SAFETY EVALUATION BY THE OFFICE OF NEW REACTORS  
LICENSING TOPICAL REPORT MUAP-07007-P, REVISION 6  
“HUMAN SYSTEM INTERFACE SYSTEM DESCRIPTION AND  
HUMAN FACTORS ENGINEERING PROCESS”  
MITSUBISHI HEAVY INDUSTRIES, LTD.

## LICENSING TOPICAL REPORT MUAP-07007-P (REVISION 6)

### “HUMAN SYSTEM INTERFACE SYSTEM DESCRIPTION AND HUMAN FACTORS ENGINEERING PROCESS”

MITSUBISHI HEAVY INDUSTRIES, LTD.

Figure 1: Soft Switch

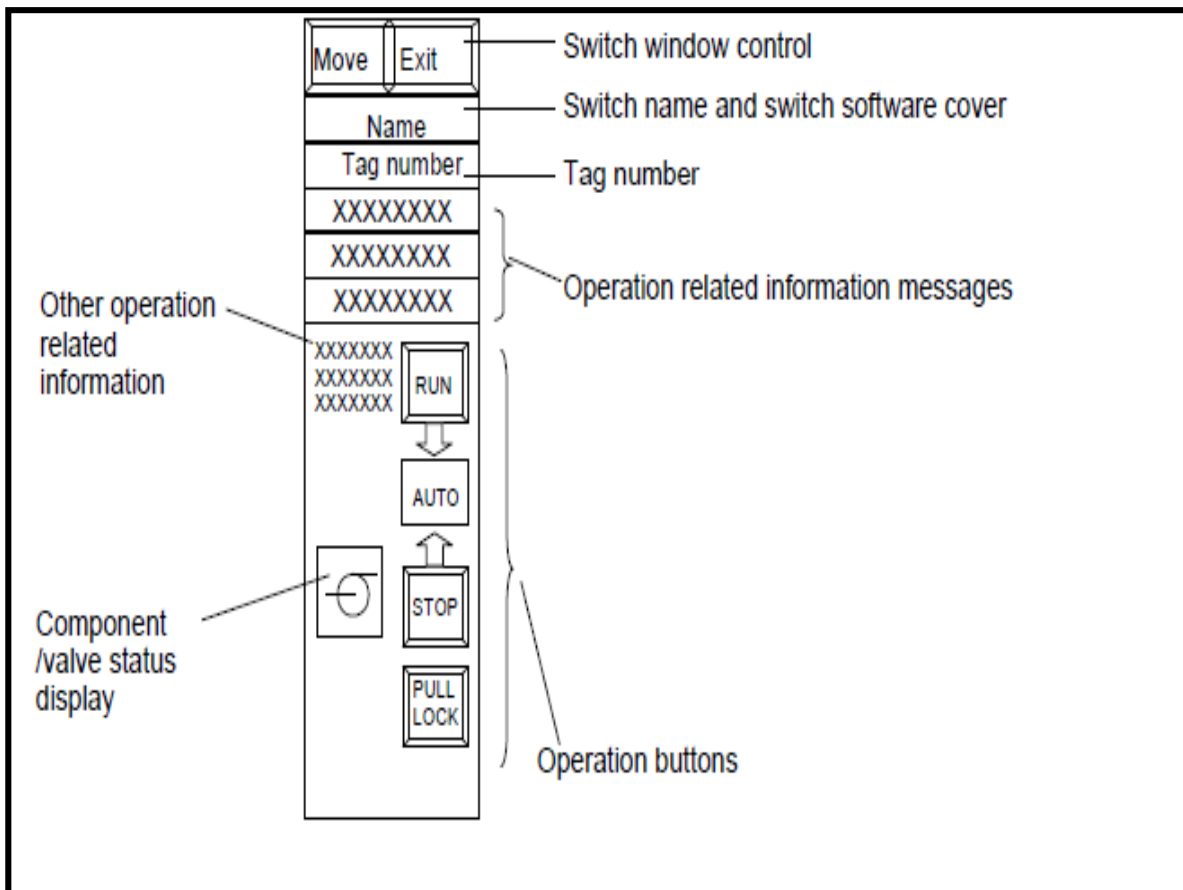
Figures 1, “Soft Switch,” and 2, “Soft Controller,” of a typical soft switch and a soft controller are provided below to help illustrate the HFE design that has been incorporated in each.

Soft control input is made by way of discrete-adjustment interfaces usually in the form of a button (i.e., start/stop, open close for a soft switch and increase/decrease buttons for controller settings). Discrete versus continuous-adjustment interfaces are preferred because the settings can be established by fairly gross movements. For controllers, setpoints can also be input using a numeric keypad function. Immediate feedback on the control activity is provided via the component status icons and in the case of controllers the bar graph display of target, process and deviation values. Since controllers provide continuous control functions they can be difficult to use due to digital system processing delay. To avoid the stress, confusion, and overshoot often caused by typical manual demand feedback indication delay, the soft control system accepts the demand signal, displays the target point in the manual value bar and sends the target values to the controller. A discrepancy between the demanded value and the value in the controller is easily seen by the operator.
